Transportation Planning Guidance

F. E. Warren Air Force Base

Cheyenne, Wyoming

April 2001

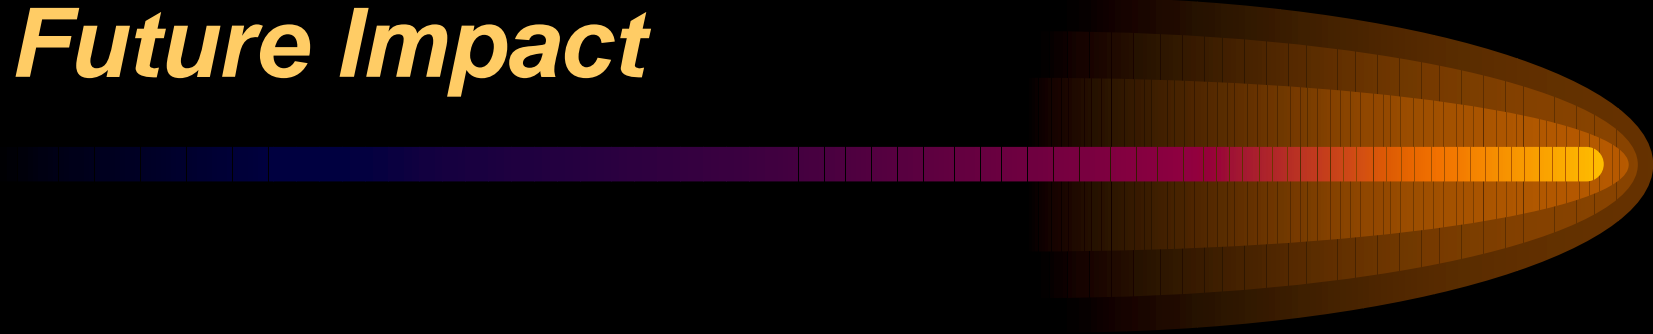
- The consolidation of functions into the MIIIMSC will add a maximum 150 employee trips per hour to Missile Dr during the morning and evening peak hours.
- Additional operational trips involving missile maintenance activities and code pick-up will occur throughout the day between the southwest (new facility) and east (existing facilities) portions of the base.
- The weekly movement (10-15 round trips) of payload transporters (PTs) and transporter erectors (TEs) will require larger than normal intersectional radii (22.7 M or 75 ft recommended) along their primary route.
